U.S. Department
of Transportation
**Federal Highway
Administration**

In Reply Refer To:
HSSD/WZ-227

Thank you for your letter of September 23, 2005, requesting the Federal Highway Administration (FHWA) acceptance of a design modification that would combine two currently accepted systems as a crashworthy traffic control device for use in work zones on the National Highway System (NHS). The proposed design modification combines your company's FG 300 UR post as described in our acceptance letter, WZ-193, dated November 2, 2004, to be mounted to the longitudinal channelizer Qwik Kurb system as previously accepted by our letter, WZ-109, dated April 9, 2002.

CURB-MOUNTED INVISI-BASE

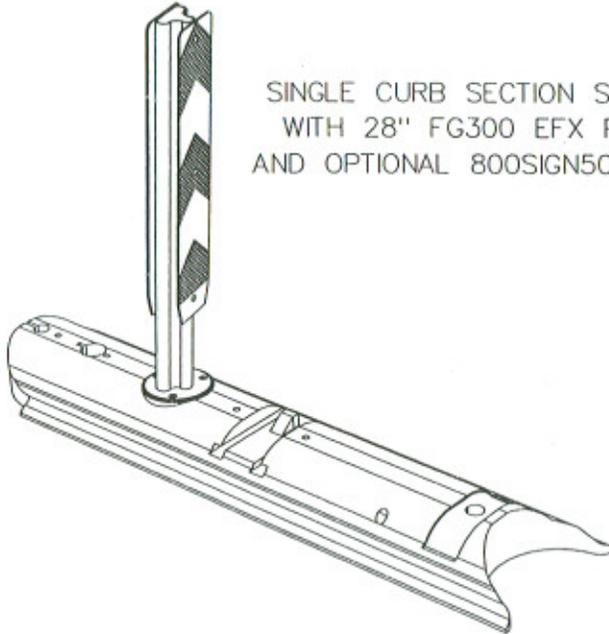
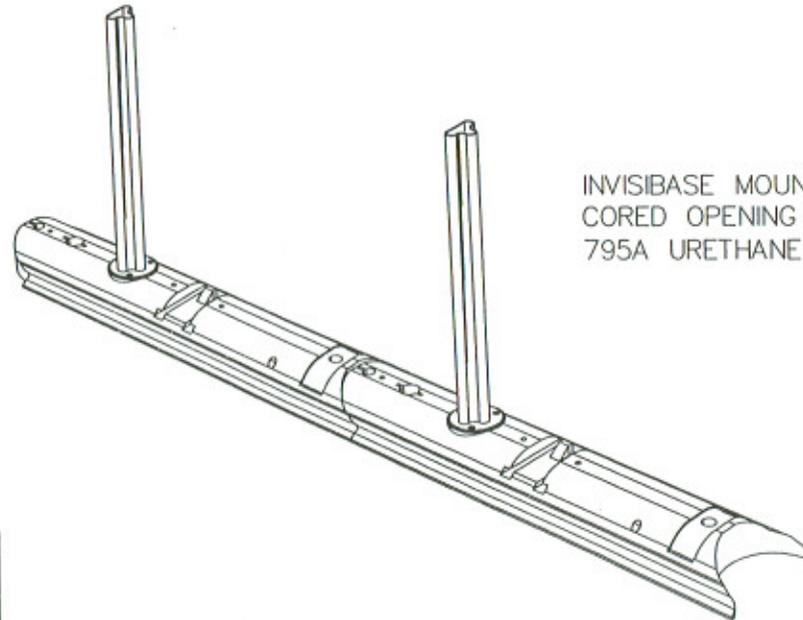
The proposed design modification involves coring an existing Qwik Kurb installation and attaching your FG 300 UR posts as shown on the enclosed drawing. You also submitted informal crash testing videos for our review in support of your request that we find the modified device acceptable for use on the NHS under the provisions of the National Cooperative Highway Research Program (NCHRP) Report 350 "Recommended Procedures for the Safety Performance Evaluation of Highway Features."

Based on our review we agree that the combination of the two previously accepted devices will not adversely affect crashworthiness and is acceptable for use on the NHS under the range of conditions tested when proposed by a State.
